Addendum No. 2
January 2, 2025

Project: First Lutheran Church Sanctuary Entrance & Bathroom Remodel
327 S Dakota Avenue
Sioux Falls, South Dakota 57104
Project #3082

Architect: Architecture Incorporated

CODE PLAN

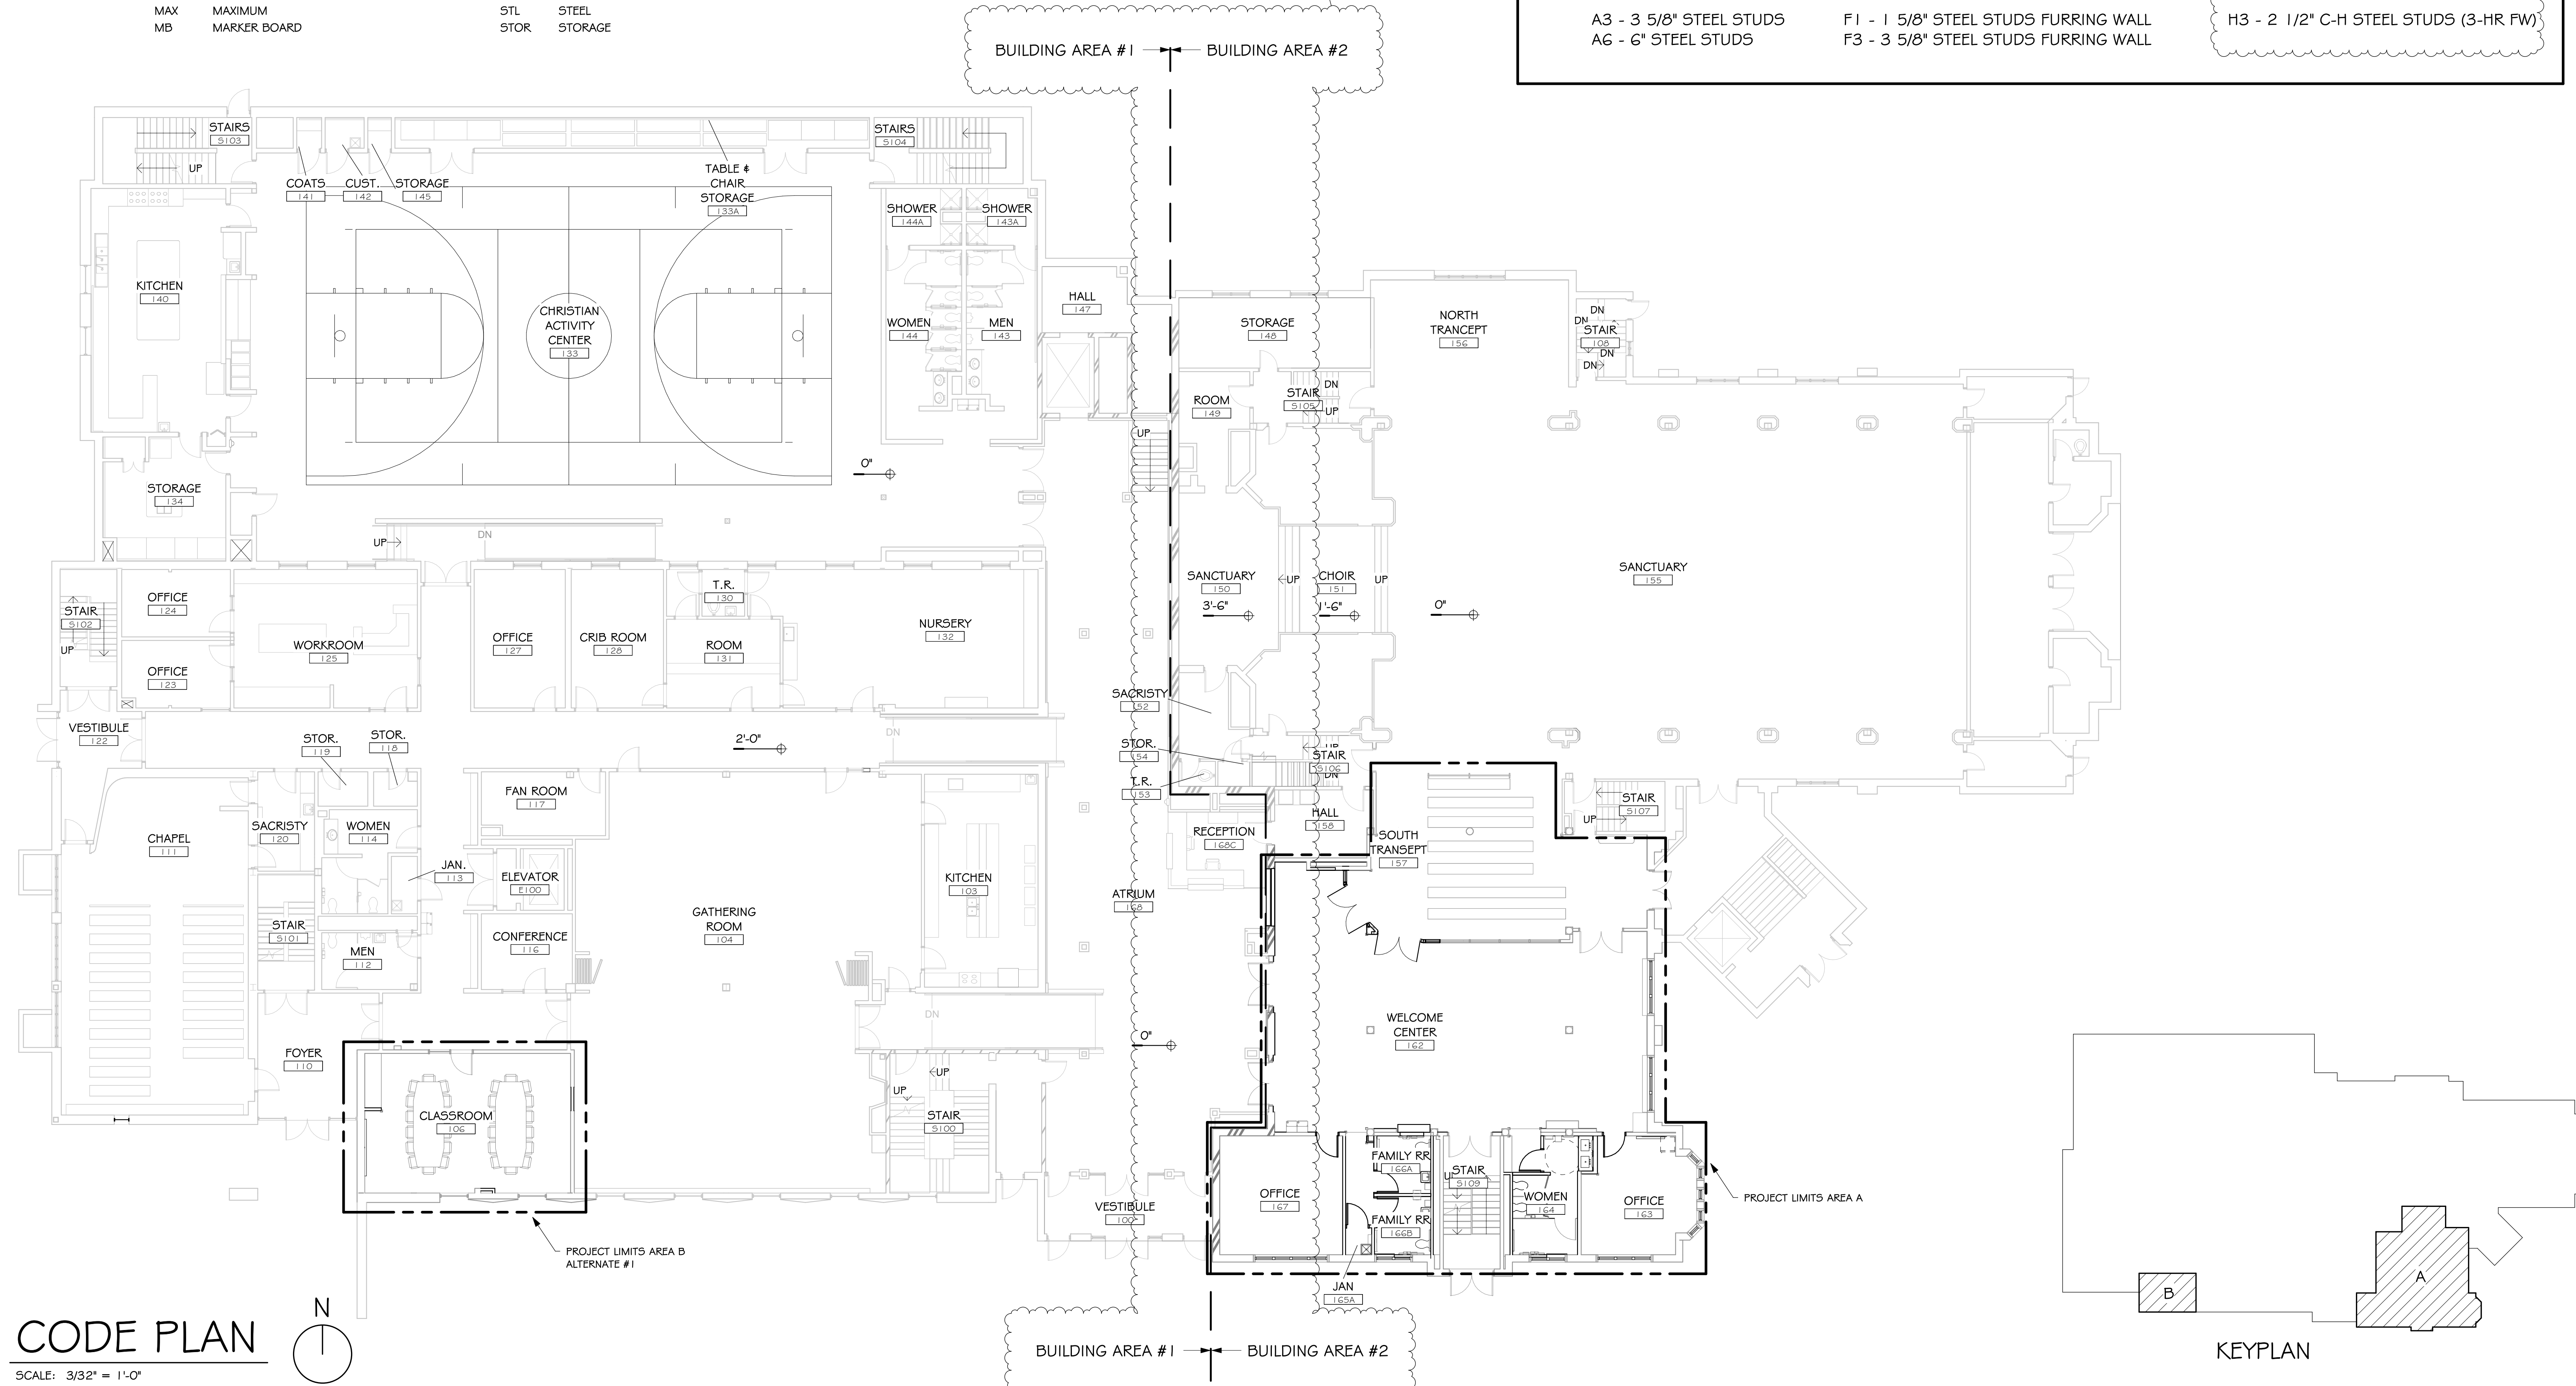
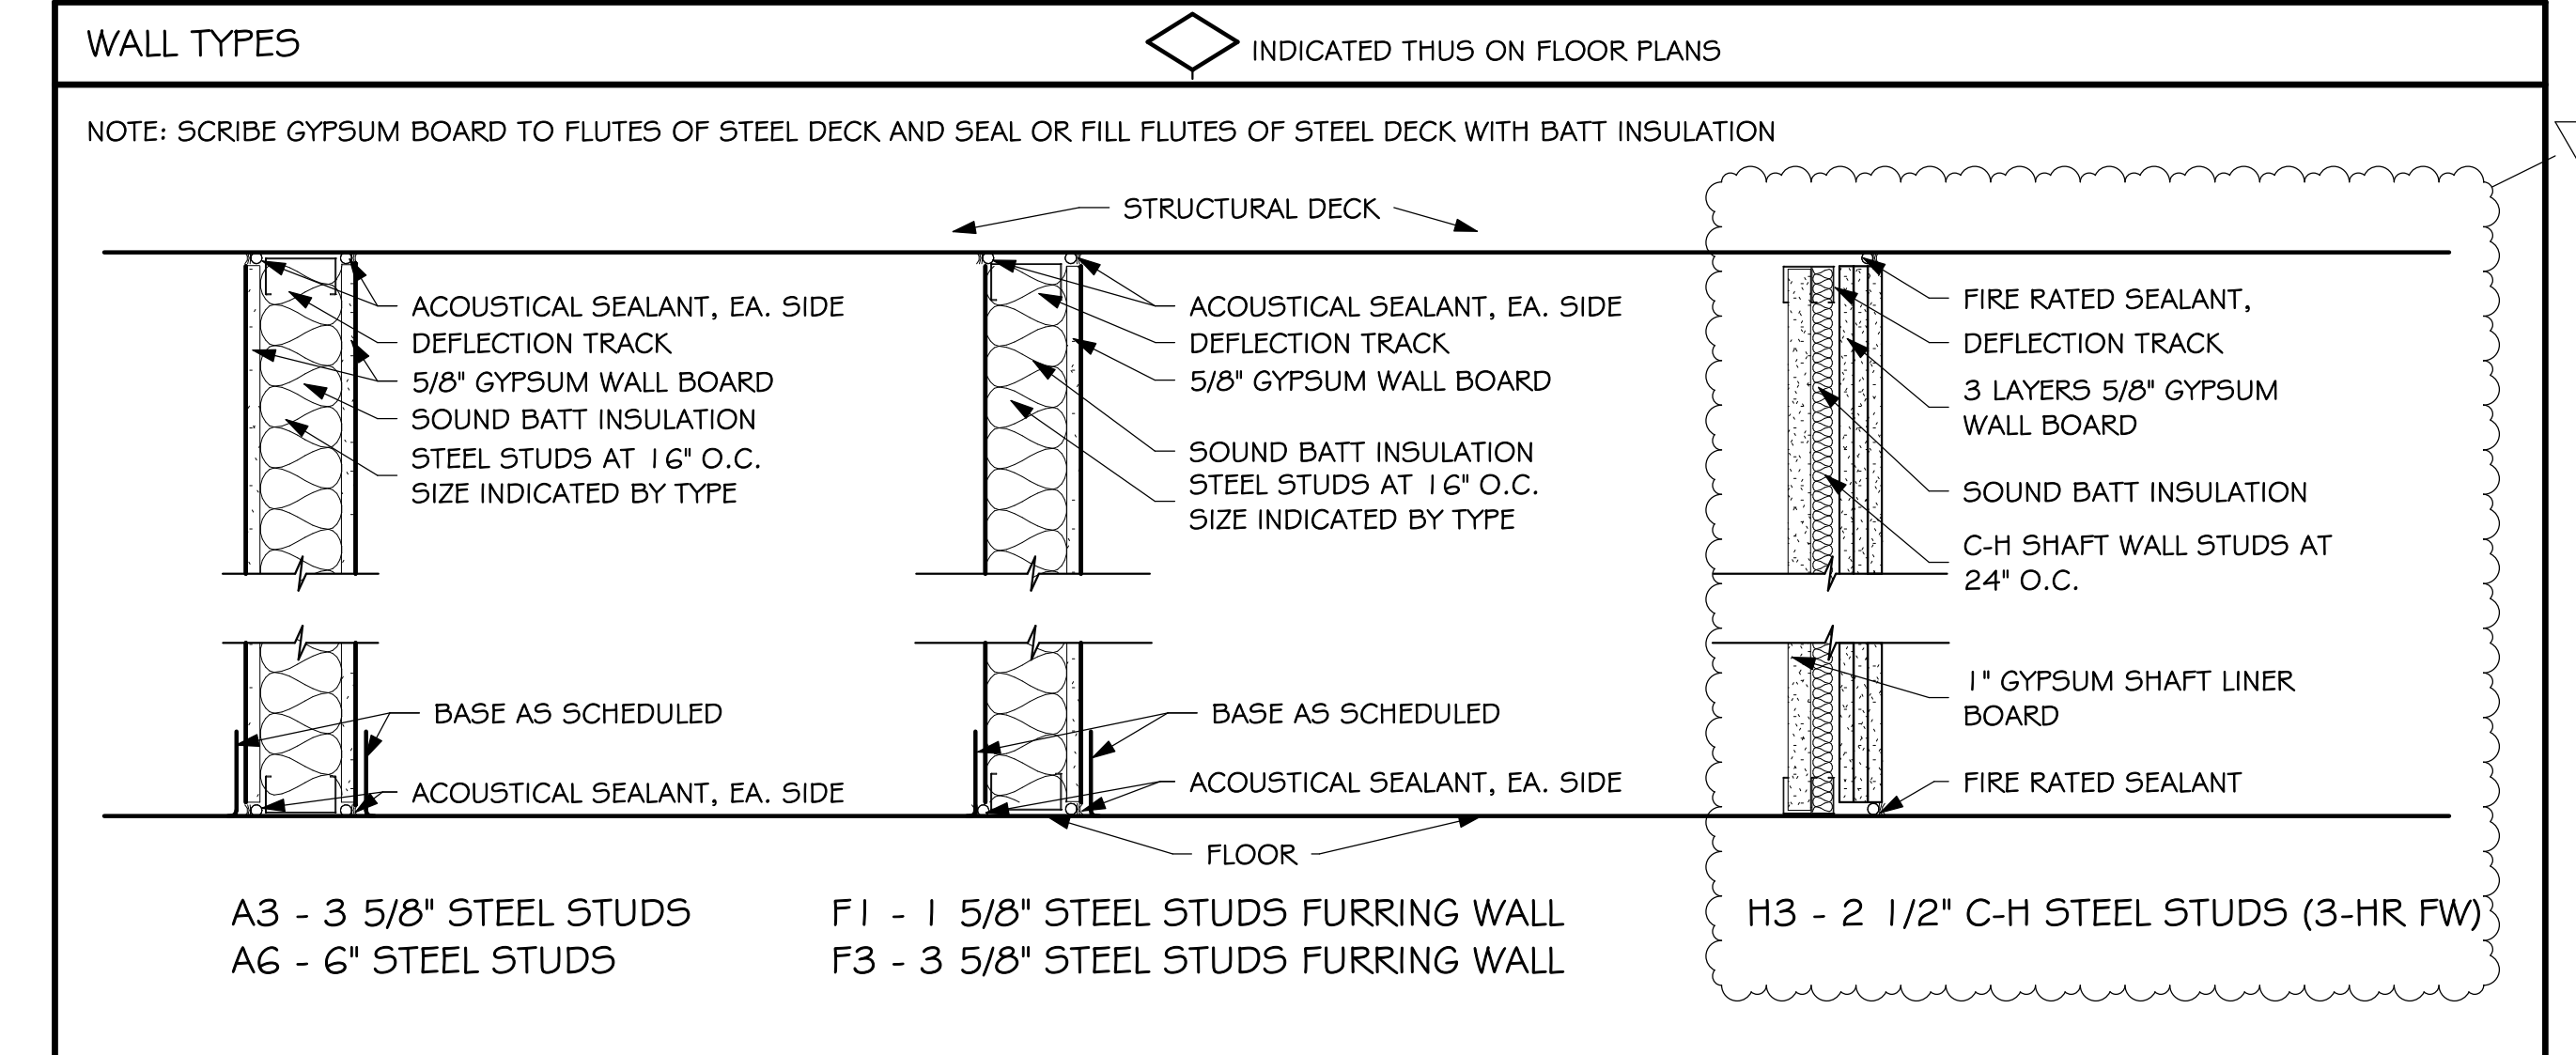
- a) Note the construction type of Building Area #2 is Type VA. Primary structural frame, bearing walls, and floor construction and associated secondary structural members are 1-hour fire rated. Those elements impacted by demolition and new construction of this project shall be patched as required to maintain the 1-hour fire rating.
- b) Reference attached revised Drawing Sheet 1.20:
 - i) The demarcation line between Building Area #1 & Building Area #2 has been identified on the Code Plan.
 - ii) Clarification of the Building Code information – Building Area #2 has a fire sprinkler system.
 - iii) Refer to Wall Types scheduled for modifications to Wall Type H3.

13 PLAN DETAIL
SCALE: 1/2" = 1'-0"

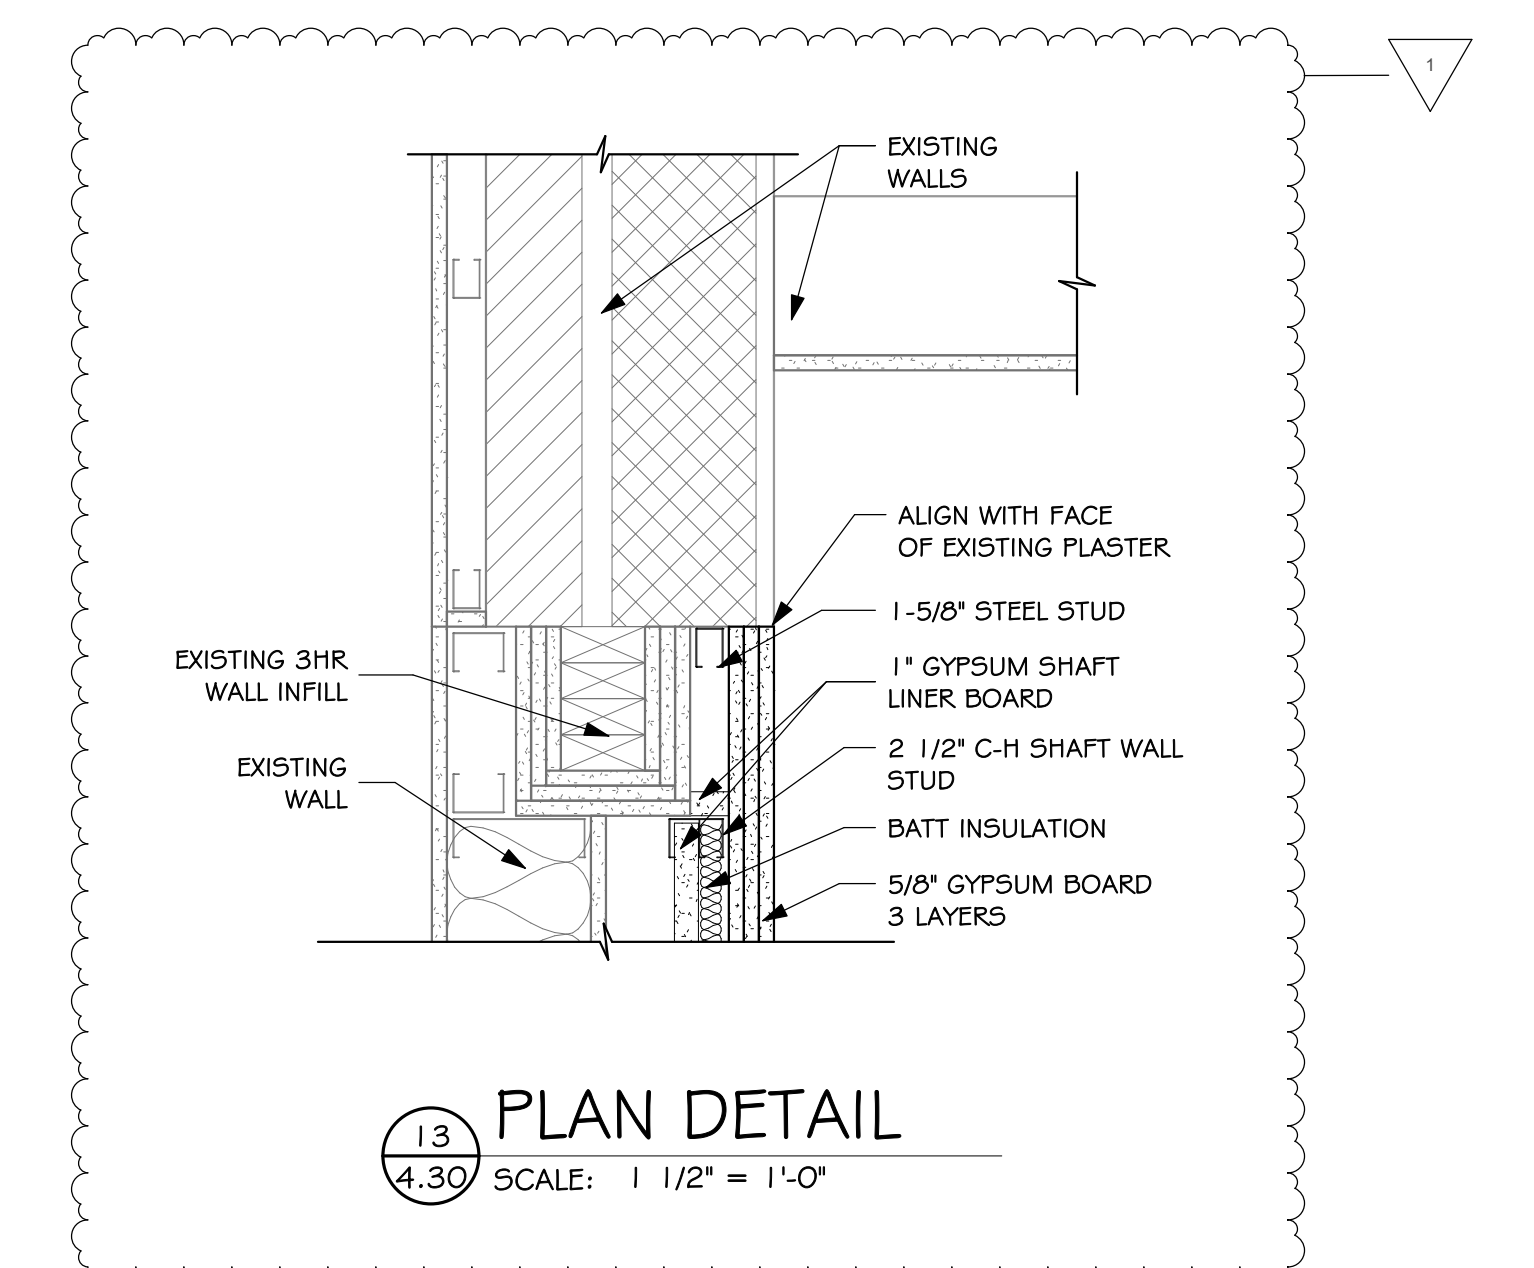
- a) Reference attached revised Drawing Sheet 4.30 for modifications to Detail 13/4.30. Note the approximate dimensions of the coiling door opening to be infilled are 8'-0" x 4'-6". The Contractor is responsible for field verifying this information.
- b) Reference attached revised Drawing Sheet 4.30 for modifications to Detail 14/4.30.
